Meeting of the Board of
Adjustment
March 4, 2025 at 6:00 PM
Council Chambers, City Hall
200 Lincoln Avenue

Case No: 2024-9316
Hearing Date: March 4, 2025
Agent: Greg Reid / Plan A Architecture
Applicant: Grace Community Church
Request: Special Use Permit
Location: 2247 Camino Carlos Rey
Case Mgr: Claudia Kath
Zoning: R-5 (Religious Assembly – 1.5 Acre)
Overlay: None
Pre-app Mtg: October 26, 2023
ENN Mtg: August 21, 2024
App. Rec'd: October 4, 2024
Proposal: Special Use Permit request for a New Assembly Area Building adjacent to an existing church building located on a lot totaling approximately 1.5 acres.

Case #2024-9316. 2247 Camino Carlos Rey, Grace Community Church, Special Use Permit. Plan A. Architecture, LLC, Agent, for Grace Community Church, Owner, requests Special Use Permit approval to construct a New Religious Assembly Building. The property, located at 2247 Camino Carlos Rey, is zoned R-5 (low-density residential) and has an existing church building on the lot of 1.5 acres. (Claudia Kath, Case Manager, cmkath@santafenm.gov.)

1 SITE ACCESSIBILITY and EGRESS PLAN
1/16" = 1'-0"

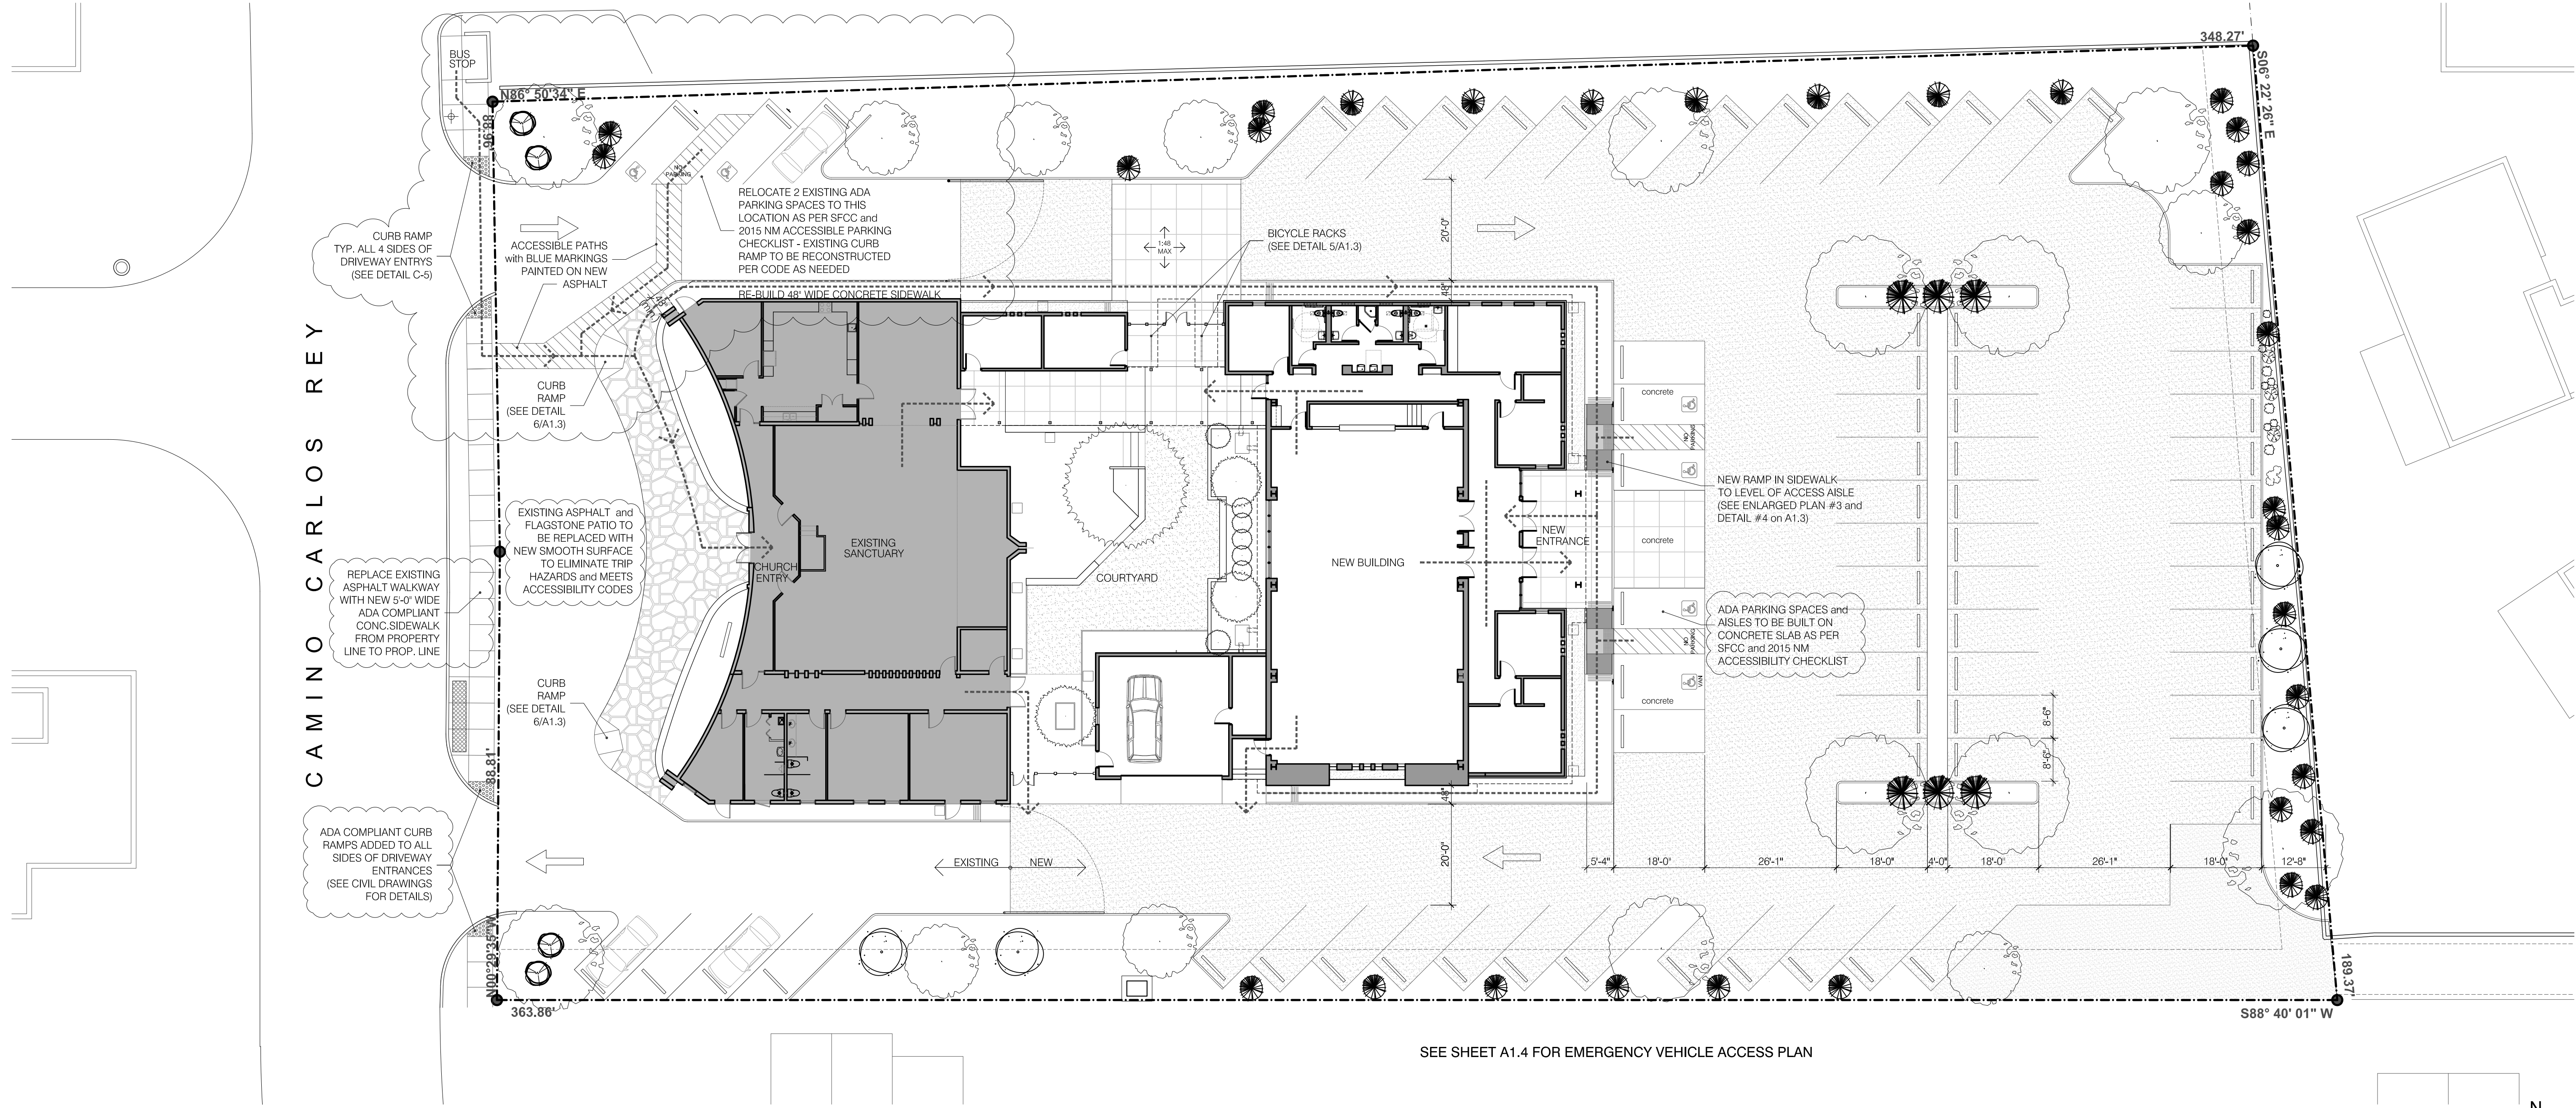
Technical Corrections:	Must be completed by:	Applicant response**:
1. Must have an Accessible Route from the Public Right of Way to the building entrance.	See sheet A1.3 for accessible routes from Bus Stop and Public Right-of-Way to entrances to both the existing church and the new building. Crosswalks will be painted on new asphalt surface.	Route from PROW through the parking area must be visible and comply with floor surfaces

2. Accessible path(s) of travel route shall be provided from the Public Right-of-Way and accessible parking aisle(s) to accessible building entrance(s) and shall comply with Section 302, floor surface, 303.4 Ramps, 401 Accessible routes, 403 Walking surfaces, 405 ramps. Ensure accessible route(s) from the Public Right-of-Way and accessible parking space aisle(s) to building entrance(s) are provided and maintained. Provide detectable warning surfaces at curb ramps and transitions to driveway crossings along the accessible paths of travel as applicable.	See sheets C-5, A1.3 for accessible routes from ADA parking aisles and Public Right-of-Way to entrances to both the existing church and the new building. All ramps and walking surfaces to comply with sections 302, 303, 401, 403, and 405. Detectable warning surfaces to be provided as required. Refer to details on sheets C-5, A1.3.

SITE LIGHTING AND PHOTOMETRIC PLAN
 1/16" = 1'-0"

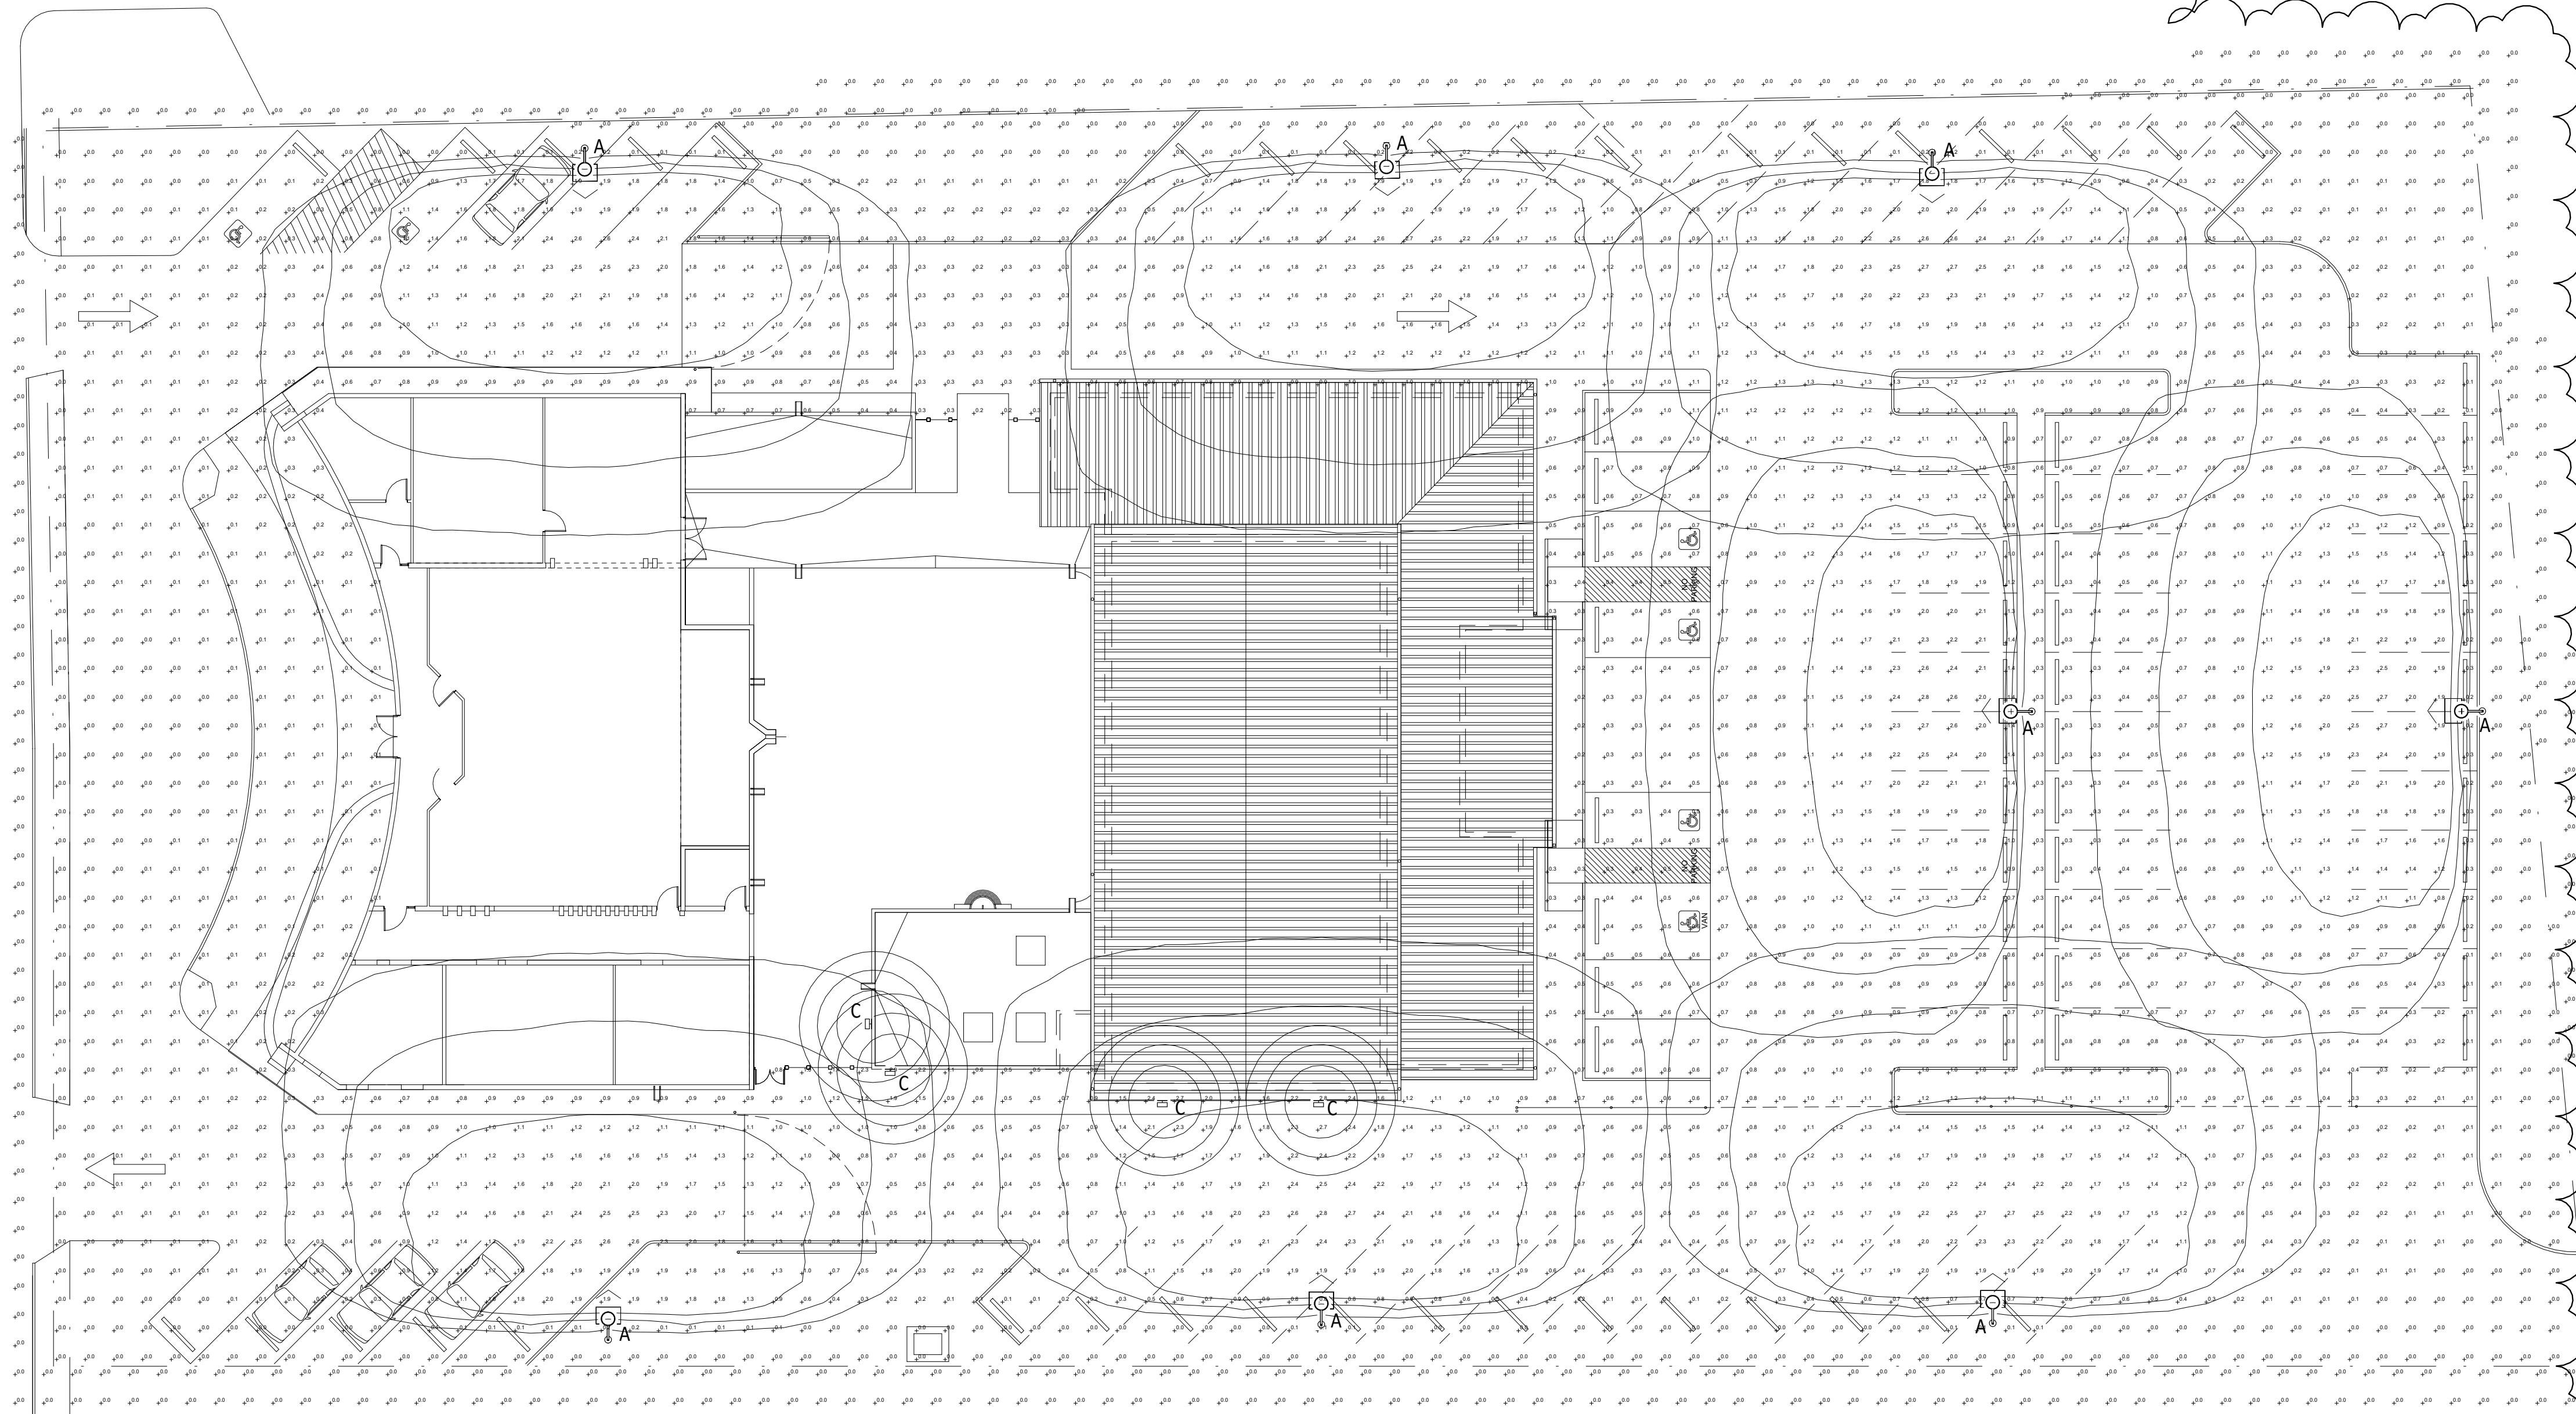
The Applicant has submitted a lighting plan with a photometric analysis. The Technical Review Division found the lighting plan non-compliant to SFCC §14-8.9 "Outdoor Lighting." A Condition of approval has been included in Attachment A of this report to address compliance prior to submitting for a building permit.

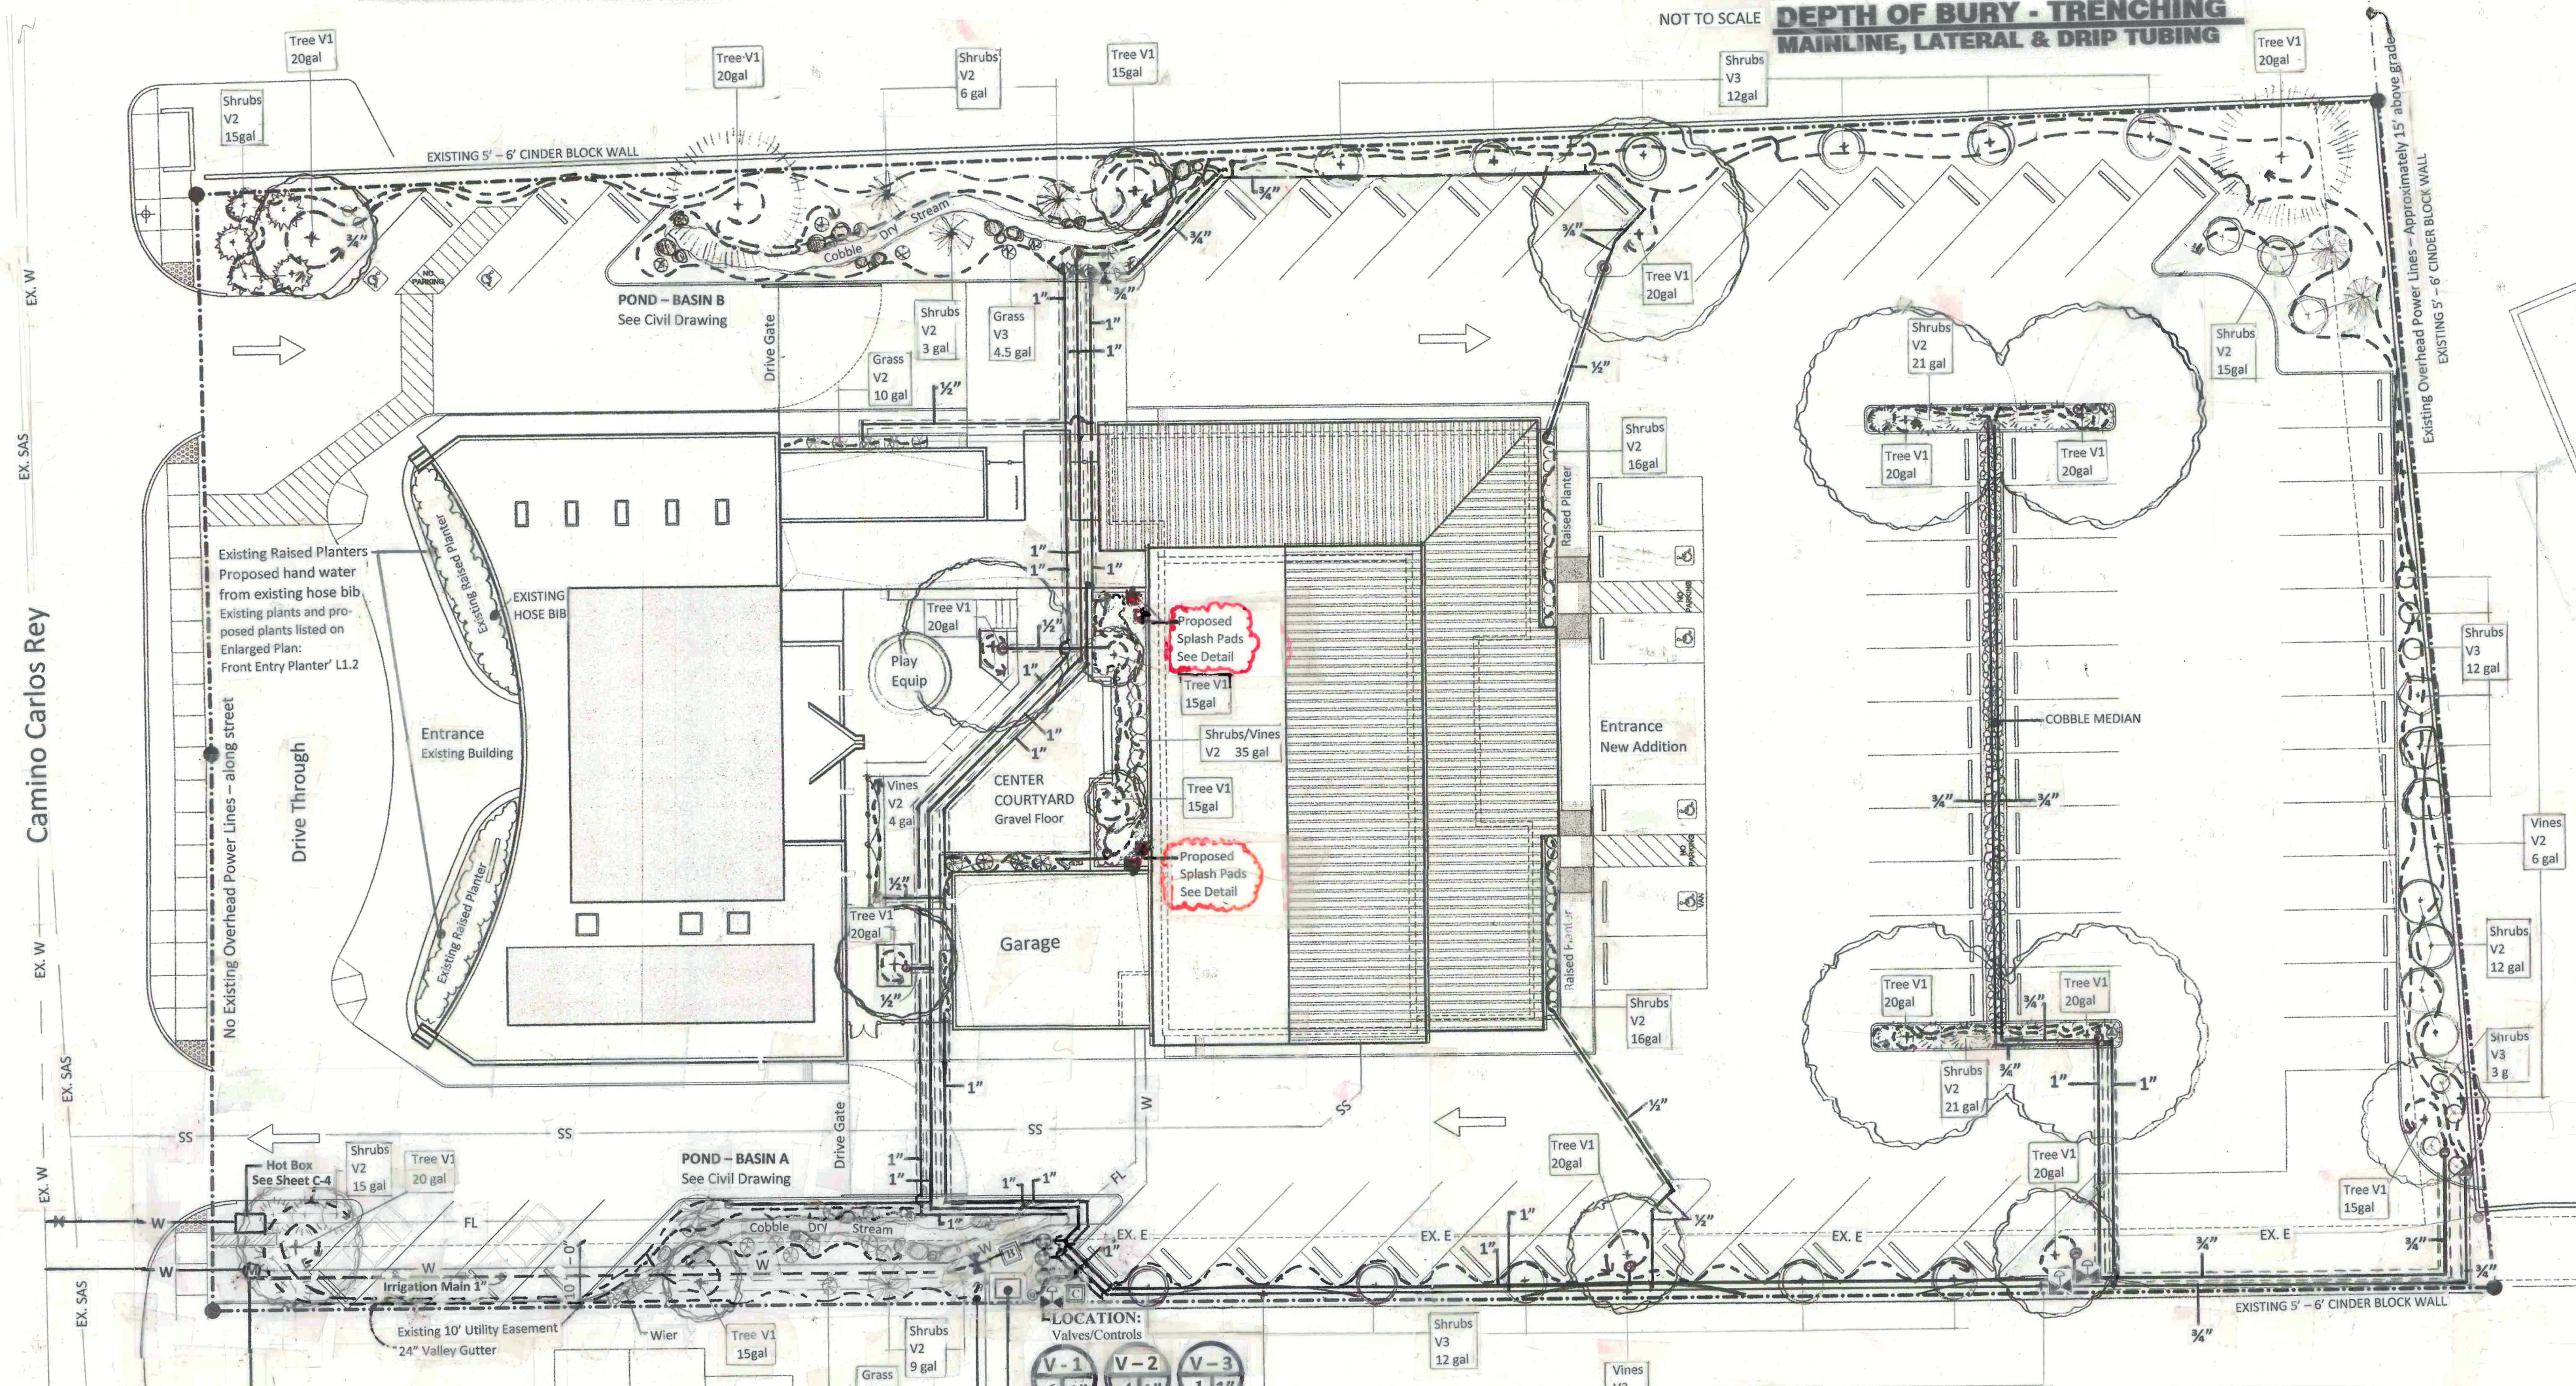
5. Provide a complete set of installation details, notes and specifications for the irrigation	Prior to permit review

system. Show in the detailed drawings the installation of all assemblies without any questions for size or type of materials to use for said irrigation system.

6. Provide a dedicated irrigation meter.	Prior to permit review	
7. 4.2.1. Automatic Control Valves B. Include in all valve manifolds schedule 80 PVC unions downstream of each control valve for easy removal and repair, per COSF Irrigation Design Standards.	Prior to permit review

8. Irrigation water lines shall not cross city water mains.	Prior to permit review	
9. 4.2.2. Isolation Valves: A. Where systems have master valve assemblies, provide an isolation valve in the valve manifold upstream of the master valve , the recommendation is a ball valve. B. If the irrigation system dose not have a master valve or the master valve is more than 10 feet from the point of connection (POC) then include an isolation valve at the POC, the recommendation is a ball valve per COSF Irrigation Design Standards. C. Were systems have a single automatic control valve in the manifold assemble in a single valve box, provide an isolation valve for each valve per COSF Irrigation Design Standards. D. Where systems have multiple automatic control valves in the manifold assemble in a single valve box, provide a minimum of one isolation valve in the manifold upstream of the control valves per COSF Irrigation Design Standards.	Prior to permit review
